**A summary of changes made to the landscape documents since
Reserved Matters Application Number 243124 (approved 20/06/25)**

Application 243124 (approved 20/06/25)	The revised landscape documents
Landscape Design Statement	CH038-001	M	O
Landscape Masterplan	CH038-002	M	P
S106 Areas	CH038-003	L	N
Tree Planting Plan 1	CH038-004	D	F
Tree Planting Plan 2	CH038-005	D	F
Tree Planting Plan 3	CH038-006	D	F
Tree Planting Plan 4	CH038-007	D	F
Tree Planting Plan 5	CH038-008	D	F
Plant Schedule	CH038-009	B	
Canopy Cover Calculator	CH038-010	B	D

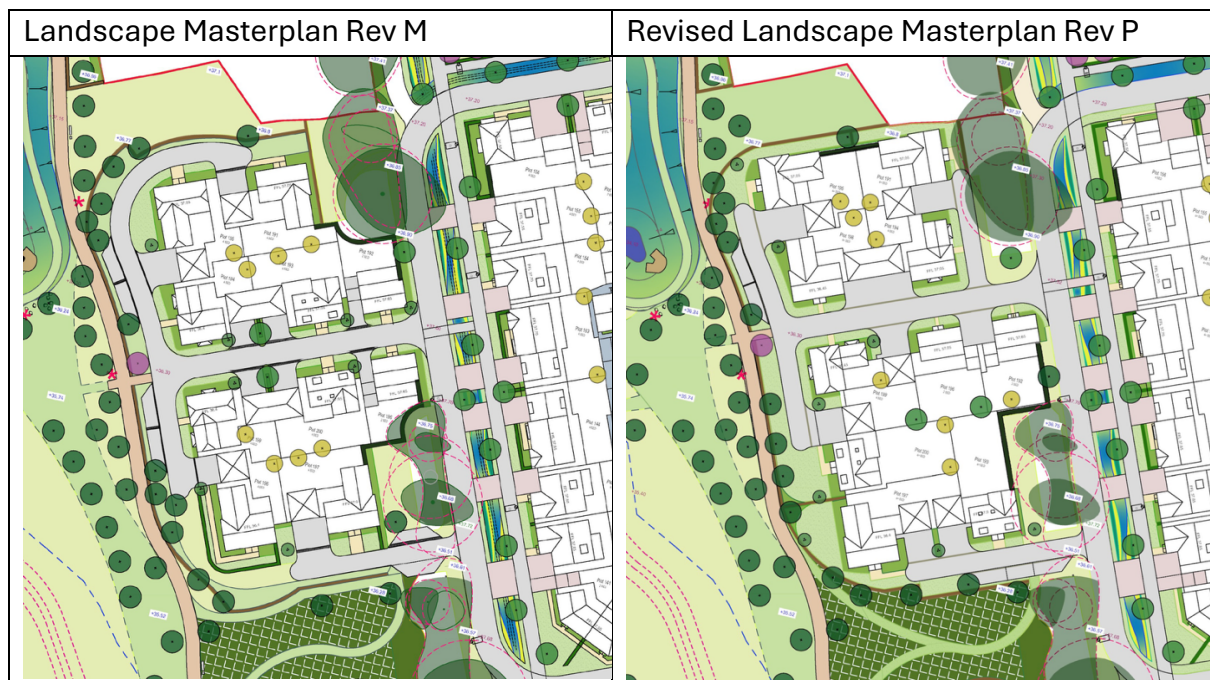
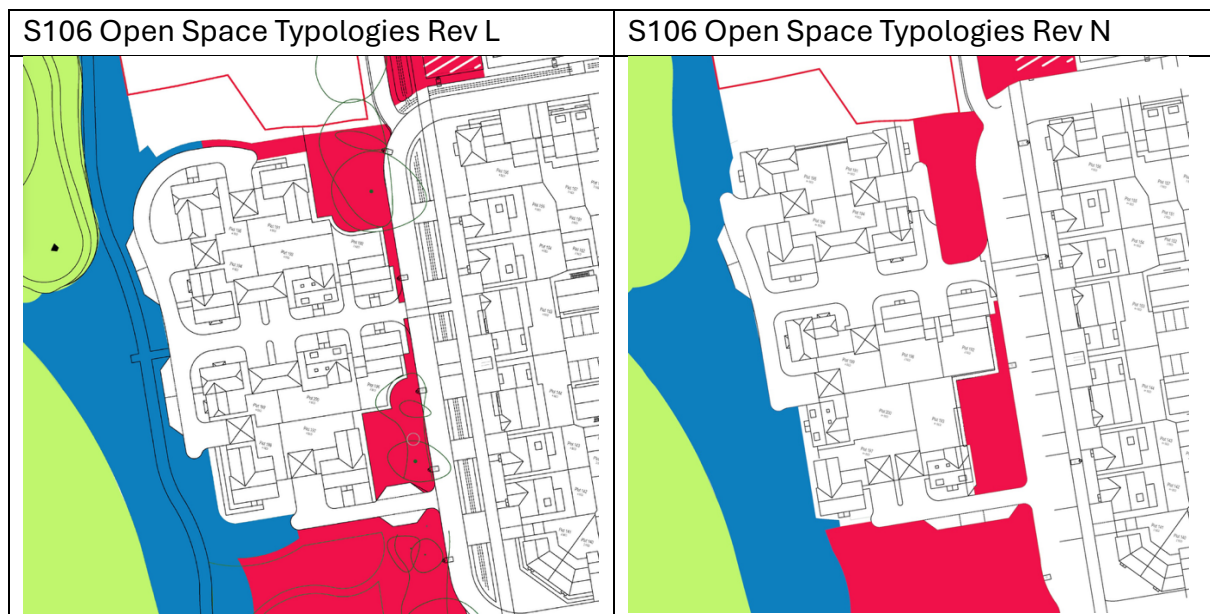
1. Site Layout.

The layout of proposed buildings, gardens, roads and parking has changed in the parcel comprising plots 191 – 200. Therefore, the layout of soft landscape shown in the landscape documents has changed accordingly.

The changes are;

- The location of tree planting. (The changes have a negligible effect on the proposed tree canopy cover which still stands at 25%).
- The location and arrangement of tall evergreen hedge forming rear side garden boundaries.
- The location and arrangement of low hedge forming front garden boundaries.
- The extent of grasslands and ornamental planting associated with front gardens.
- The arrangement of the native hedge that separates the development area from the Water Meadows open space area to the west.
- The extent of TG14b (as identified on CH038-007 Tree Planting Plan 4) and reflected in CH038-010 Canopy Cover Calculator.xls
